UNITED STATES PATENT AND TRADEMARK OFFICE

| APPLICATION NO. | FILING DATE | FIRST NAMED INVENTOR | ATTORNEY DOCKET NO. | CONFIRMATION NO. |
|-----------------|-------------|----------------------|---------------------|------------------|
| 09/853,276 | 05/11/2001 | Randall D. Blanchard | LITD:0013 | 5871 |

Office Action Summary

DETAILED ACTION

Fig. 1

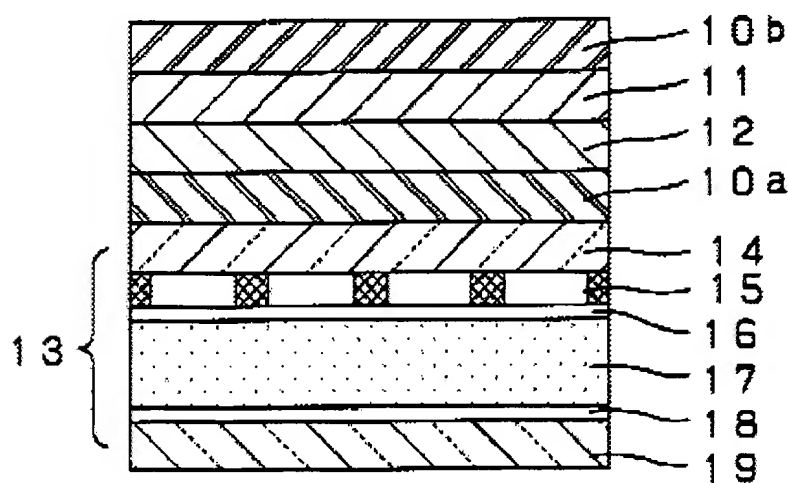
As to claims 1, 2, 5, and 15, Hatanaka discloses in Embodiment 2 (col. 7, line 35 through col. 8, line 20) and Figures 1-3, a liquid crystal display (LCD) comprising:
a liquid crystal cell display screen, 13;

a polarizer, 11 (Applicant's transparent panel), having a backside and an anti-glare front surface configured to diffuse ambient light comprising an anti-reflective layer disposed on the anti-glare front surface (col. 8, lines 1-6); and

a front scattering film layer, 10a (Applicant's bulk diffuser), wherein the bulk diffuser comprises a diffusive material configured to diffuse light within the diffusive material (col. 7, lines 49-67), disposed between the display screen, 13, and the backside, wherein the bulk diffuser is bonded (col. 7, lines 65-67 and col. 8, lines 3-7) to the display screen and the transparent panel, and

the bulk diffuser is configured to diffuse image light of the display (col. 7, lines 49-67).
